Serial No. 06-273
ESP/JDH
Docket No. 52-008

DOMINION NUCLEAR NORTH ANNA, LLC
NORTH ANNA EARLY SITE PERMIT APPLICATION
RESPONSE TO NRC QUESTIONS AND REVISION 6 TO THE NORTH ANNA ESP APPLICATION

Enclosure 1
Dominion Response to March 2 and
March 13, 2006 NRC Questions

NORTH ANNA UNIT 3 CLOSED CYCLE CIRCULATING WATER SYSTEM DIAGRAM

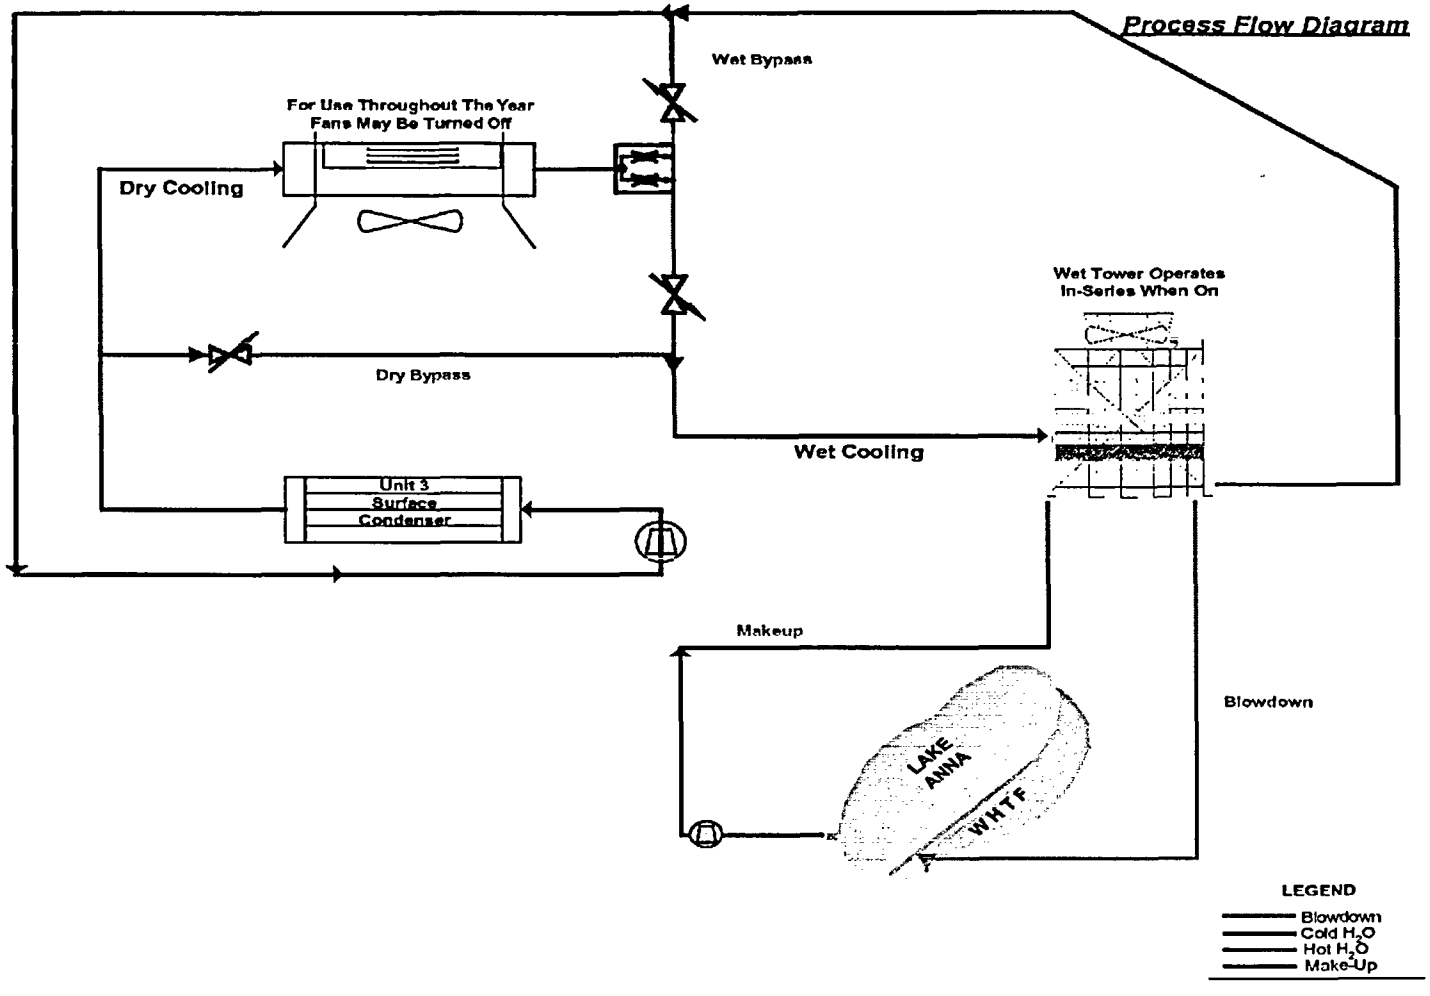
The normal plant cooling system is a closed cycle system combining dry and wet cooling towers to provide the capability to reduce water consumption during drought conditions. The process flow diagram for the system is shown in the attached Figure. In the Maximum Water Conservation (MWC) mode of operation, heated cooling water leaving the plant main condenser would be cooled in a dry cooling tower section where a minimum of one-third of the heat would be rejected. The cooling water passes through the tubes of the dry cooler while fans move air across the outside of the tubes to transfer the heat to the air. After passing though the dry coolers, the water then passes through a wet cooling tower section, where the remaining heat is dissipated by spraying the water into an air stream, achieving the majority of the heat transfer by evaporation of a portion of the water. The cooled water then returns to the plant condenser to condense the steam leaving the turbines. When the system is in the Energy Conservation (EC) mode of operation, the dry tower fans are turned off with 100% of the cooling then provided using the wet tower section.

ER Section 3.4.1.1 is revised to include the diagram of the cooling system shown in the attached Figure and to describe examples of the water saving features that could be used in the wet towers. The figure in the ER Section also includes a plant service water system described in the section.

Figure 1: Flow Reduction ($\Delta Q = Q_2 - Q_3$) over Dam (from October 1978 to April 2003)

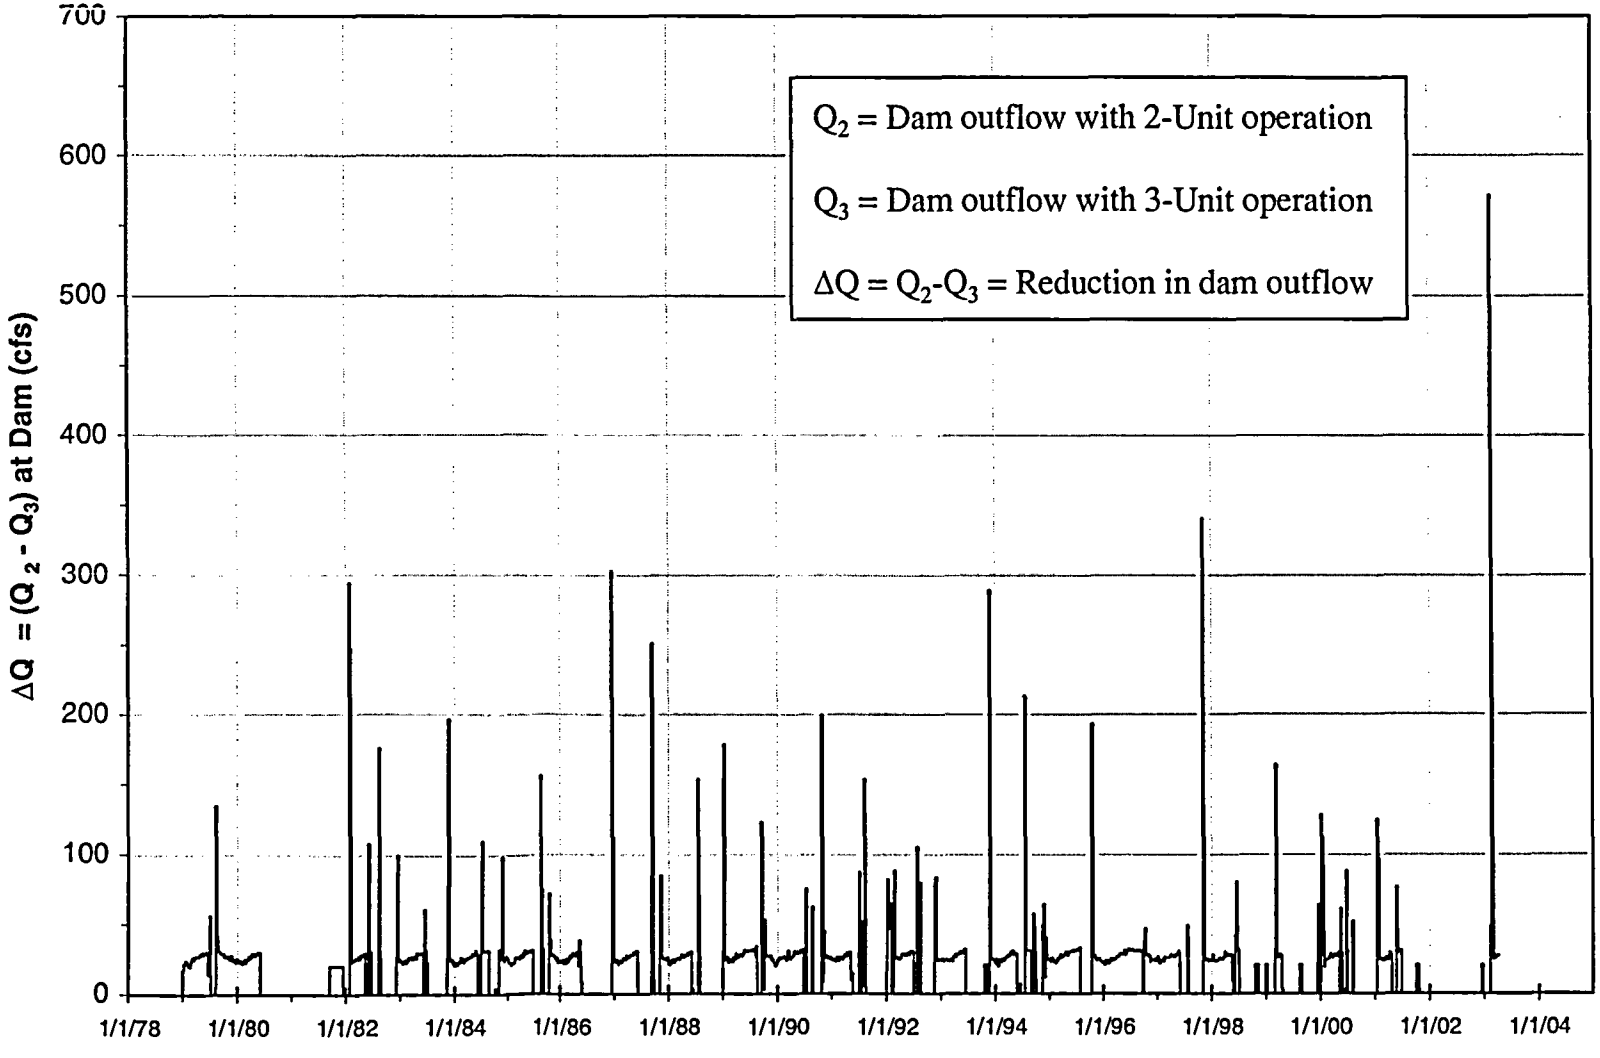
a. **Section 5.2.2.2 states that the frequency of reduced flow from the dam would increase. Provide an analysis of the impact on fish and other aquatic communities in the North Anna River downstream of the dam. Specifically, address how the reduced water flow rates would affect environmental conditions at known striped bass spawning habitat areas during the striped bass spawning season.**

Certain characteristics of the changes in flow at the dam between 2-unit and 3-unit operation are apparent from these calculations as illustrated in Figure 1:

- There are short periods with a difference of 20 cfs, e.g., when 2-unit operation is releasing 40 cfs minimum flow, but 3-unit operation, with a lower lake level, would release 20 cfs, which would have occurred seven times in the 1978-to-2003 period, lasting one week to 3 months;

- There are periods when the 2-unit dam release is much larger (up to 550 cfs, but mostly 100 to 350 cfs) than the 3-unit release, due to the fact that runoff after a dry period fills the reservoir level to elevation 250 ft more rapidly for the 2-unit case and nearly all the river inflow is passed over the dam for a short period before the reservoir would have filled under the 3-unit scenario. Flow differences above 100 cfs would have occurred approximately 25 times in the 1978-to-2003 period, with each episode lasting a few days to two weeks.
